Environmental Services - Water Quality
Onsite Wastewater Scan Data Entry Form

WAKE COUNTY DEPARTMENT OF ENVIRONMENTAL SERVICES WELL AND SEWAGE SITE LOCATION PERMIT
NO PERMIT(S) FOR CONSTRUCTION, LOCATION OR RELOCATION ACTIVITY SHALL BE ISSUED
UNTIL AN AUTHORIZATION FOR WASTEWATER SYSTEM CONSTRUCTION HAS BEEN ISSUED
PERMIT VOID IF NOT IN COMPLIANCE WITH ZONING REGULATIONS AND/ OR IF SITE IS ALTERED OR INTENDED USE CHANGED

PLOT PLAN
OF
LOT 54
STONEWALL FARMS
WAKE COUNTY
FOR
COREY GILBERT

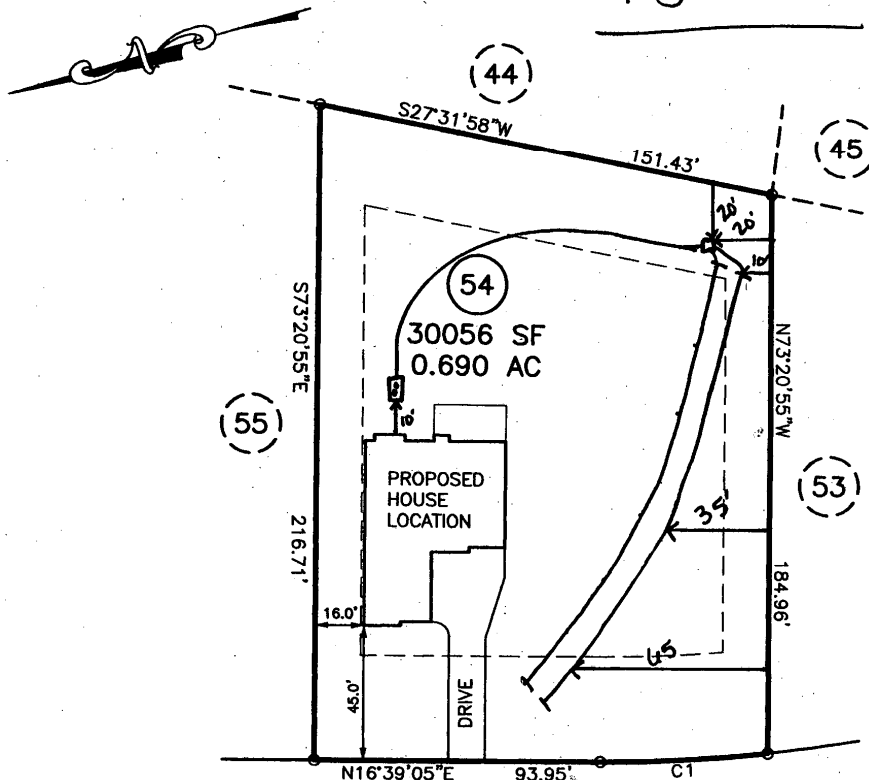
* Pump was not used. Gravity was achieved. cps
5/23/07

As Built
